NOTICE OF PROPOSED AMENDMENT (NPA) No 03/2005
DRAFT DECISION OF THE EXECUTIVE DIRECTOR OF THE AGENCY,
on certification specifications for engines (CS-E)

Miscellaneous amendments to CS-E

Figure 1. Example of the analysis results for a system with both Short Time Dispatch and Long Time Dispatch

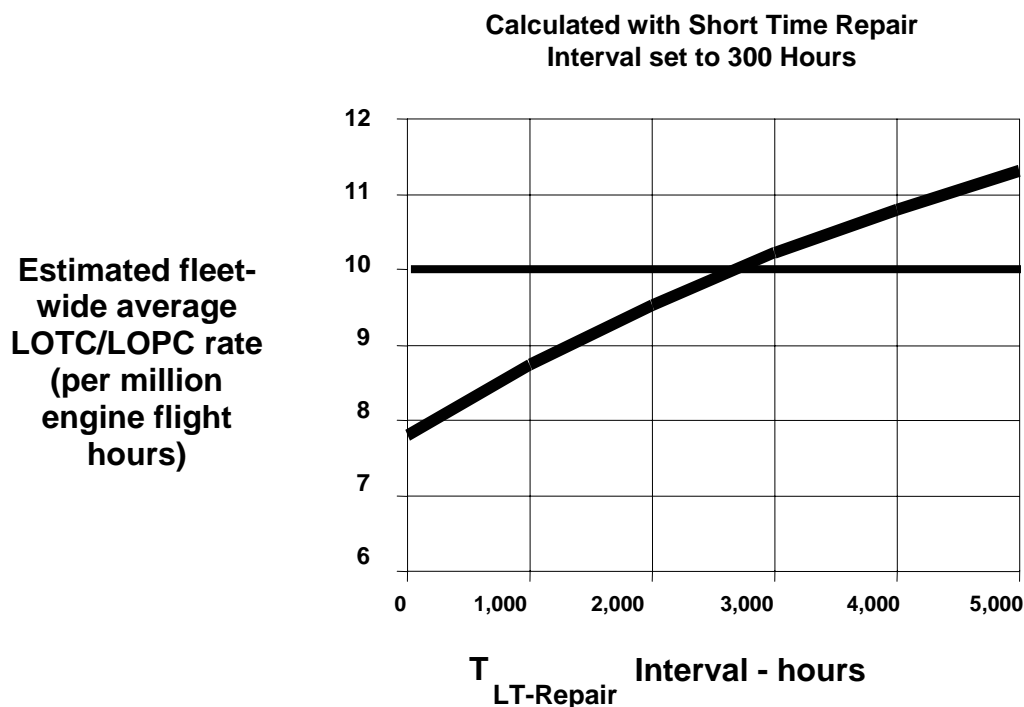
The analysis to substantiate compliance with a given LOTC/LOPC target should be summarised in a graph. An example of such a graph is shown in Figure 1. The ordinates of the graph should be the estimate of fleet-wide average LOTC/LOPC rate of the EECS versus the dispatch interval(s) (in hours) for the EECS Faults

If dispatchable EECS Faults have been grouped into two categories, a short-time dispatch (or repair) category and a long time dispatch (or repair) category (see paragraph (6) below), the ordinate of the graph should show a long time dispatch time interval of at least twice the length of time of the repair interval being requested. When calculating the LOTC/LOPC rate as a function of the long time interval, the assumed short-time interval should be twice the requested short-time interval. This factor of two is used to cover uncertainties in the analysis itself.
